Land East of Coventry Road

Cubbington, Warwickshire Response to WCC submission

Land east of Coventry Road, Cubbington **Response to WCC submission**

Drawing 17380-02aSite Access visibility splays

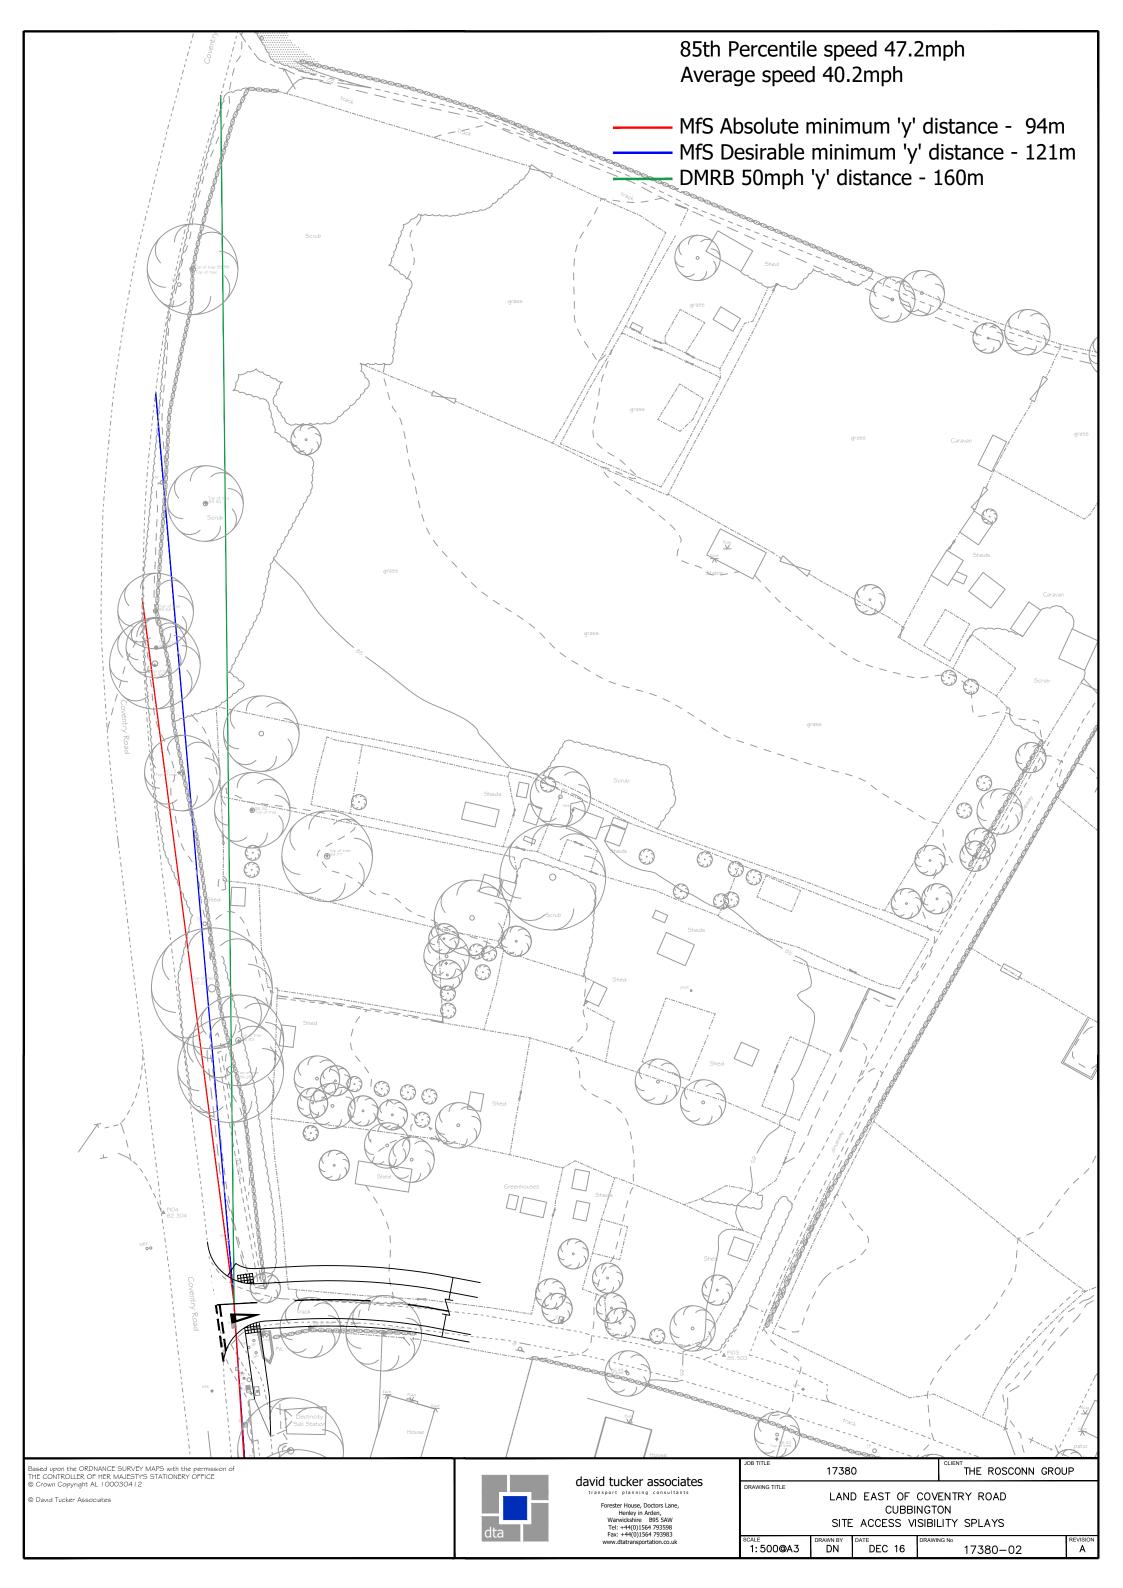
The simple answer is no as they cannot achieve suitable visibility splays. DTA are applying manual for street standards even though the 85th percentile vehicle speeds are recorded at 47.2 mph and the speed limit is 50 mph.

The Highway Authority applies the visibility standards set out within Design Manual for Roads and Bridges for any 85th percentile speeds over 40mph. The Highway Authority therefore requires a visibility splay of 2.4 metres by 160 metres. From my assessment of the drawings this cannot be achieved and a safe access cannot be secured.

In addition the access would have to be supported by a Road Safety Audit Stage One, which no doubt would raise the concerns regarding the level of visibility which can be achieved.

- Drawing 17380-02a demonstrates the requested visibility distances of 2.4m x 160m can be delivered on land under the control of the development and existing public highway. It does show that significant clearance of vegetation would be required, which could have an adverse impact on vehicle speeds. By opening up the forward visibility on approach to the village, drivers could maintain higher vehicle speeds. However, depending on the width of the tree trunks, some could be retained as they would only provide a momentary obstruction to visibility.

- 1.9 DMRB standards for a 40mph speed limit would require 120m splays. This is directly comparable to the 121m required by the MfS2 desirable minimum splays shown on Drawing 17380-02a and would therefore, provide a splay that would meet the requirements of WCC whilst also minimising the impact on the loss of vegetation and delivering a splay that would meet the 85th%ile desirable requirements of MfS2.

- 1.12 The required distance are left for agreement between the applicant and local authority.
- 1.13 Therefore, should it be considered that WCC's position regarding the application of DMRB standards on a local road is reasonable, the more onerous splays of 160m can be delivered. This demonstrates the site can be brought forward without requiring a reduction in the speed limit and being dependant on a traffic regulation order. However, there would be clear benefits in terms in providing a shorter splay by minimising the loss of vegetation and maintaining lower vehicle speeds.
- 1.14 It is important to highlight the 94m splays are in accordance with the requirements of MfS2 using the factors derived from DMRB. However, the developer would support the delivery of a 40mph buffer requiring 120m splays because it would reduce the impact on the existing vegetation compared to the 160m.

1.15 It can therefore be concluded that a variety of visibility splays can be provided to and from the site access, all of which meet the requirements of MfS2 and one of which would deliver the 50mph DMRB splay addressing the Council's concerns.
